# Access Compliance Report

## Public Rights-of-Way

### (Curb Ramps)

Intersection ID: 30220	Main Street: PATRICIA_RYAN_DR	Cross Street: MARGARET_KELLY_CT	Location: S
ADA ID: CCB98061E0DD	Ramp Type: PerpDiag	Initial Pass/Fail: Fail	Overall Compliance: No
Severity Score: 8.75			
Codes/Mitigation Info/Possible Solution		Field Measurements/Component Compliance

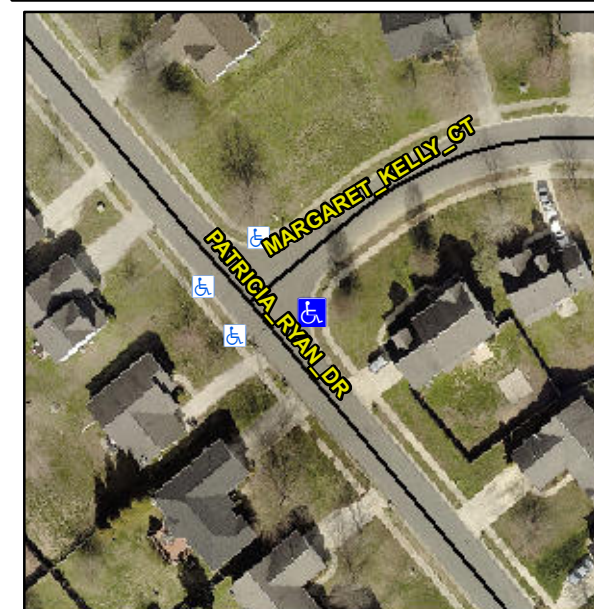
**Not Found, R304.5.1**

**Remove & Replace Curb Ramp With Two New Directional Ramps or Equivalent.**
